Re: BP#2017-00174 - 6 Commercial Street

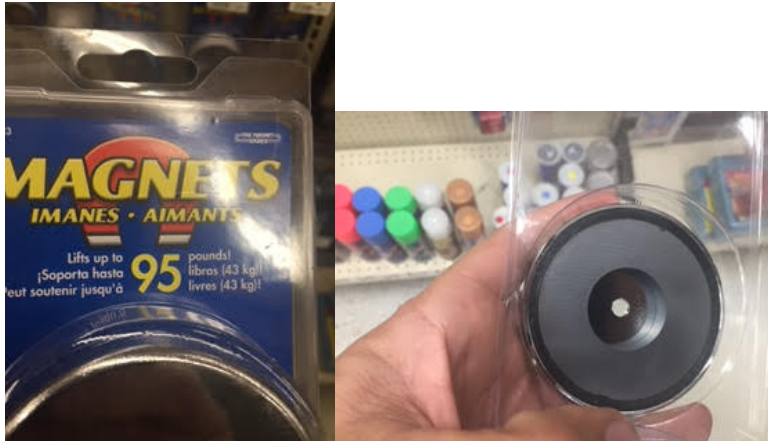
The magnets are only to keep the sign from swinging in the wind. The sign will be held up by the chains. We will bolt 4 of these to the sign.

Can you give me an idea of what size magnet you are using. Maybe forward a photo of the magnet.
